**STATE OF NEW HAMPSHIRE
SITE EVALUATION COMMITTEE**

Docket No. 2015-06

**Joint Application of Northern Pass Transmission, LLC
and Public Service Company of New Hampshire
d/b/a Eversource Energy for a Certificate of Site and Facility**

**PREFILED DIRECT TESTIMONY
OF
BETH FENSTERMACHER, ASSISTANT CITY PLANNER**

Sheet : 605

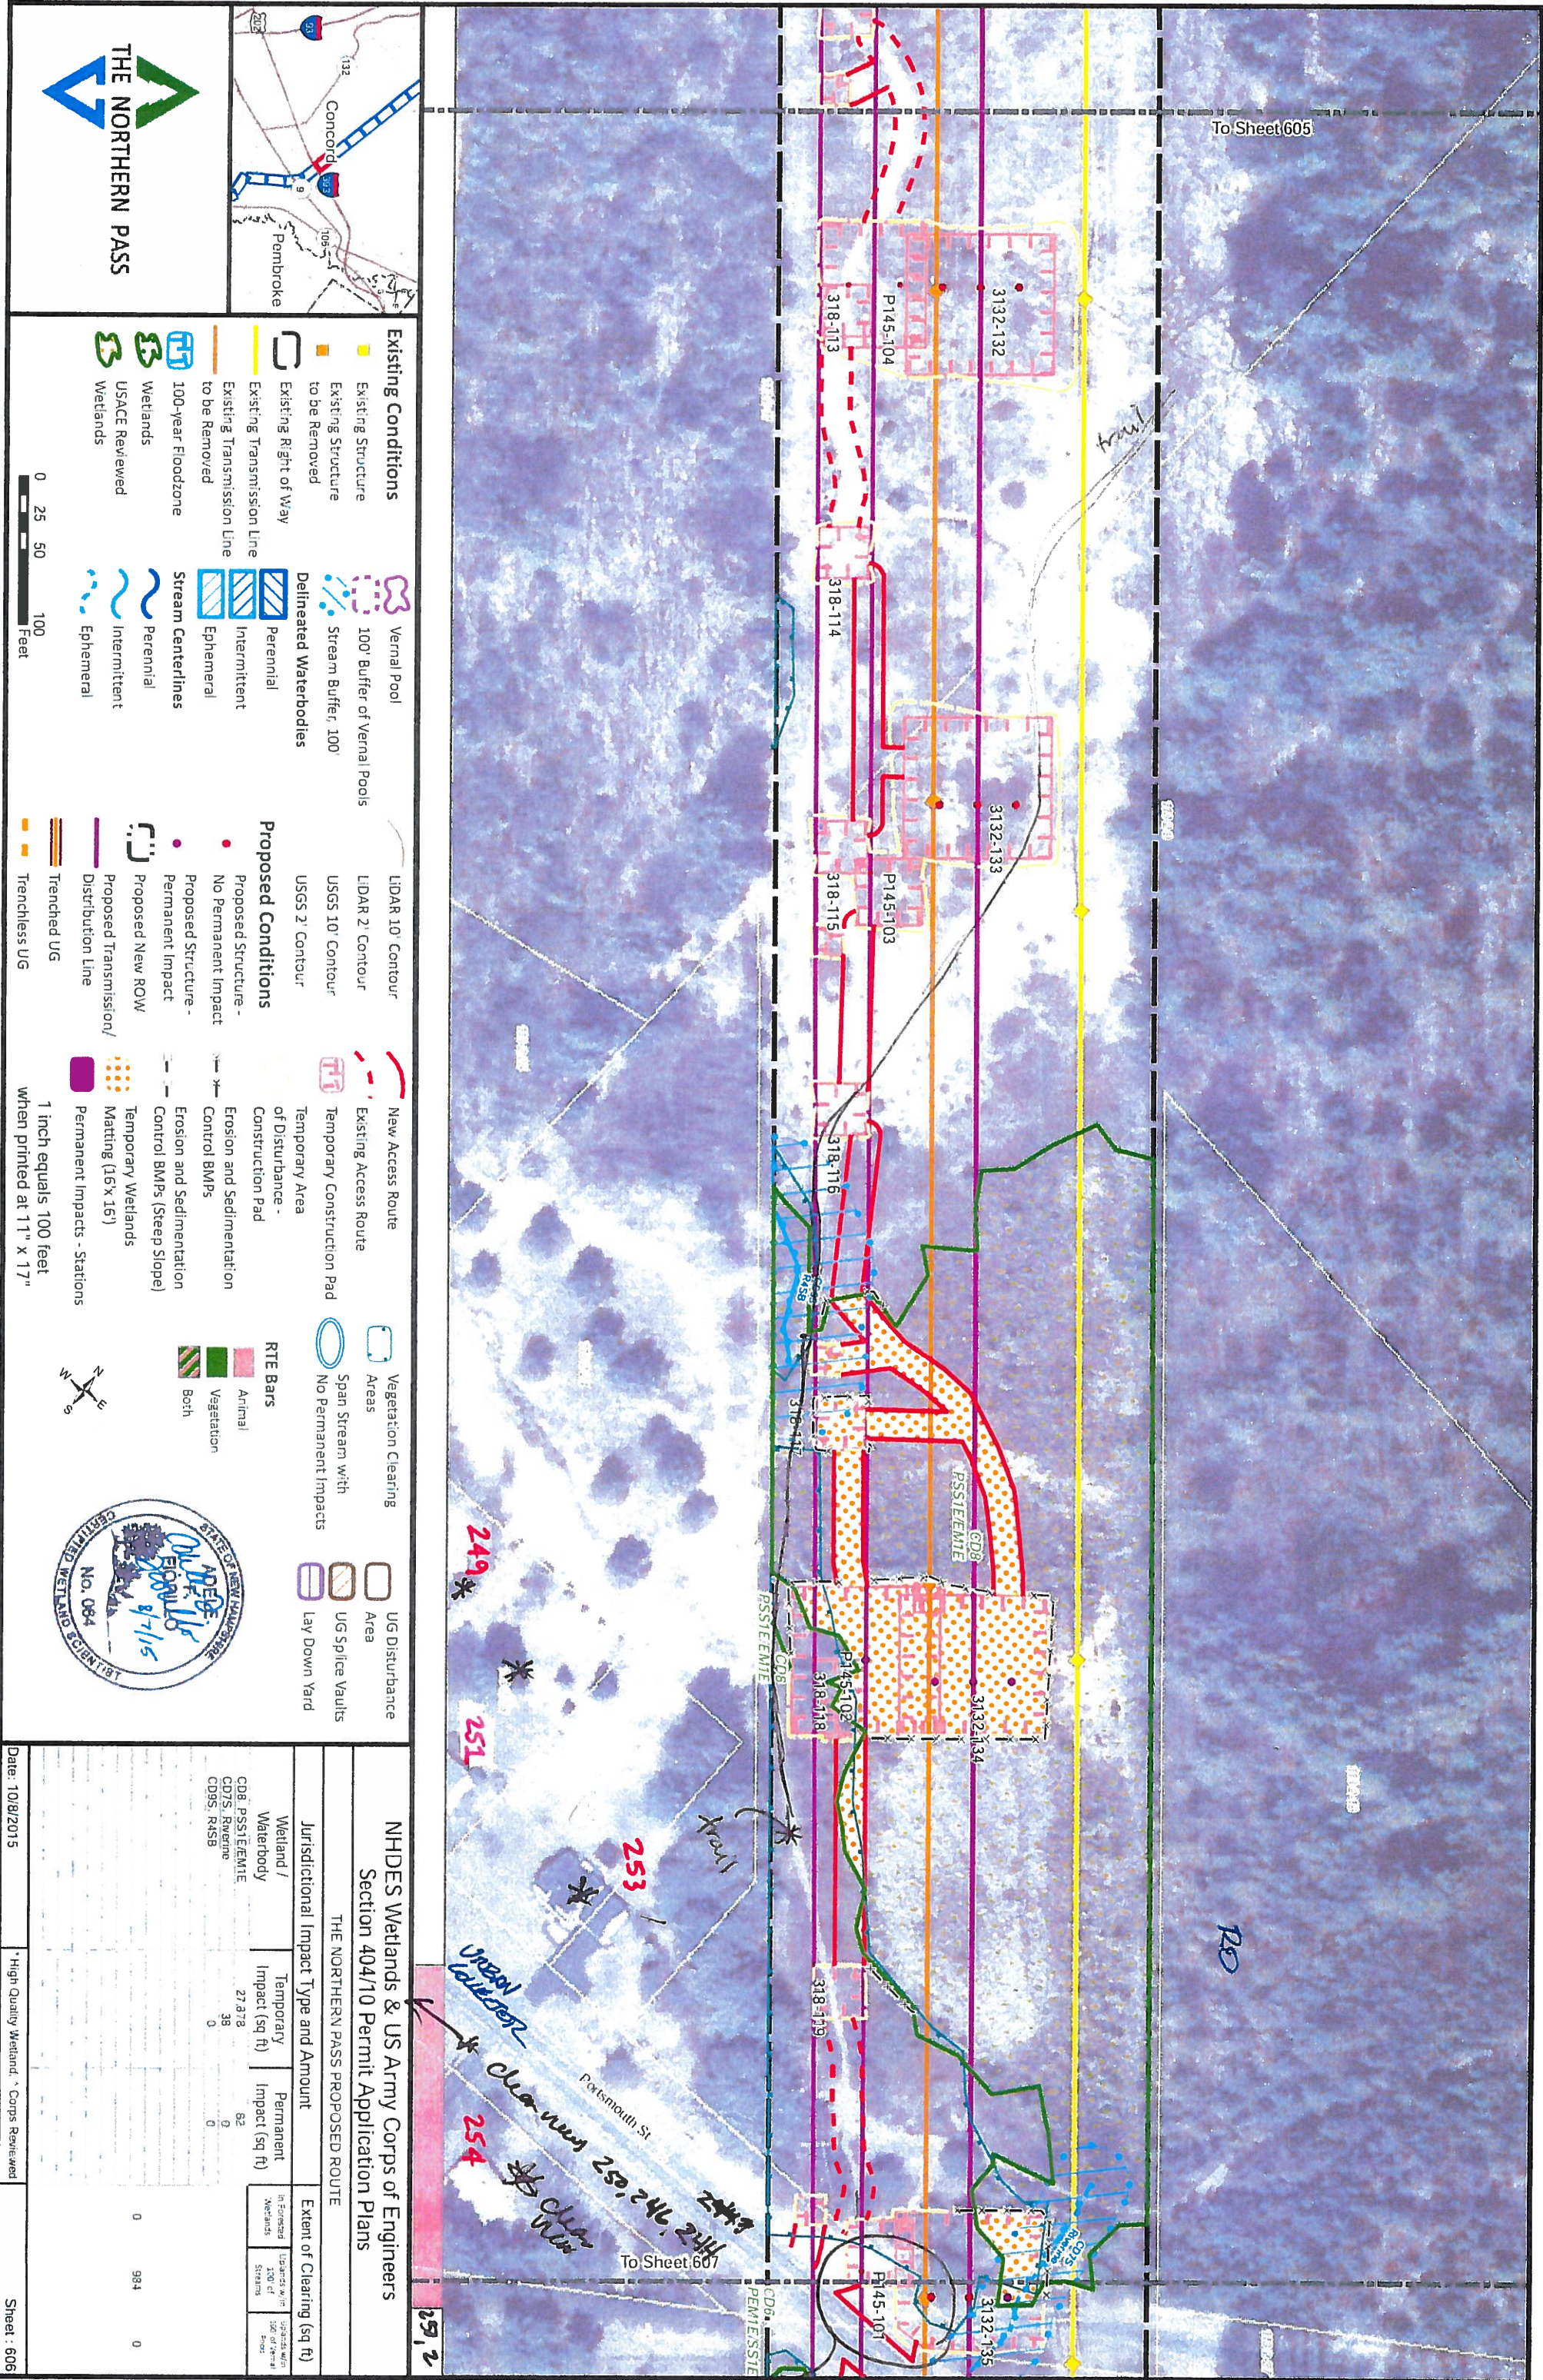
249 Portsmouth St	113-2-26	606	Existing view, more impact from pole ht. increase and clearing.		
251 Portsmouth St	113-2-20	606	Existing view, more impact from pole ht. increase and clearing.		
253 Portsmouth St	113-2-24	606	Existing view, more impact from pole ht. increase and clearing.	Buffer of trees between the transmission line and the house at 253 Portsmouth were required of Unitil by Planning Board action.	
254 Portsmouth St	113-1-3	606	Existing view, more impact from pole ht. increase and clearing.		
250 Portsmouth St	113-1-7	606	Existing view, more impact from pole ht. increase and clearing.		
246 Portsmouth St	113-1-6	606	Existing view, more impact from pole ht. increase and clearing.		
244 Portsmouth St	113-1-14	606	Existing view, more impact from pole ht. increase and clearing.		
259 Portsmouth St (City trails)	113-2-19	606	Location of City of Concord trailhead for the Broken ground trails. Construction pad is located on the trailhead, which was graded/fixed by Unitil for use by the City as part of the Unitil substation construction. Kiosk and parking will be impacted by construction.	Trailhead impacts. Buffer of trees between the transmission line and the house at 253 Portsmouth were required of Until by Planning Board action.
